Suite I, 9 Narabang Way Belrose NSW 2085 | Phone: (02) 9986 2535 | Fax: (02) 9986 3050 | www.bbfplanners.com.au

STATEMENT OF ENVIRONMENTAL EFFECTS Lot 259 Aumuna Road, Terrey Hills Modification under Section 4.55(2) to Consent DA2022/0888

Figure A2 - site proposed modifications

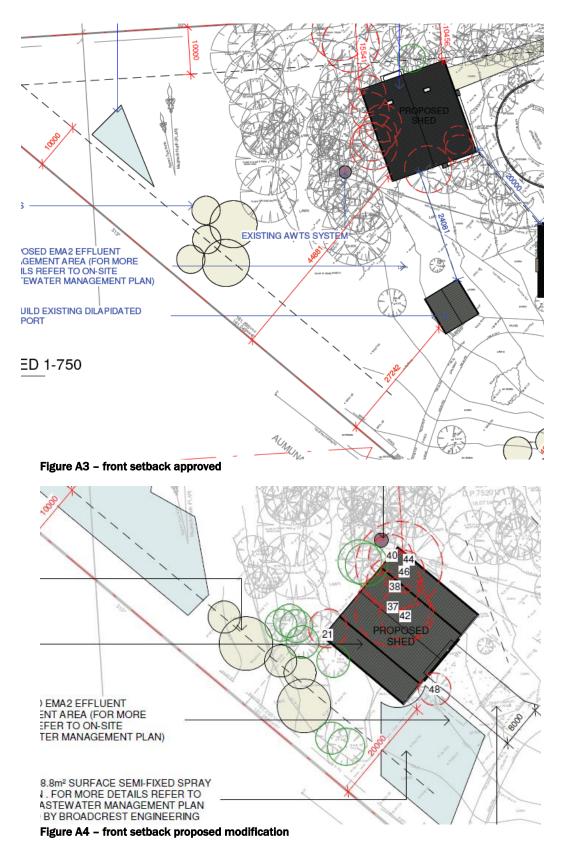
- relocation of the shed / garage
- reconfiguration of the shed / garage including changed roof profile and additional water closet
- reconfiguration and relocation of the access driveway to the shed / garage
- deletion of the carport. Car parking is now accommodated within the shed and garage
- revised materials and finishes schedule for the shed / garage
- modifications to the proposed tree removal and replanting regime
- modifications to the location and extent of the wastewater system

Figure A8 - tree retention / removal proposed modification

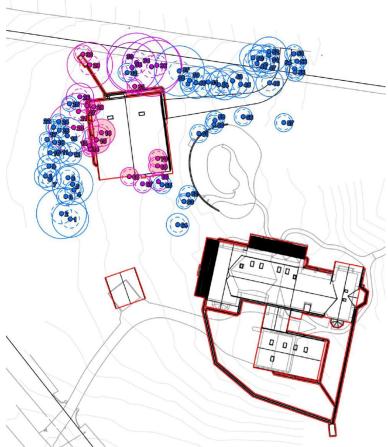
The report identifies that 97 trees were assessed, retention of 89 trees and removal of 8 trees (3 less than approved by DA2022/0888) is proposed (figure A8 in Annexure 1). The replanting of native trees (Lilly pillies) has already been undertaken on the site (details on the architectural plans) and no additional replanting is proposed by the DA.
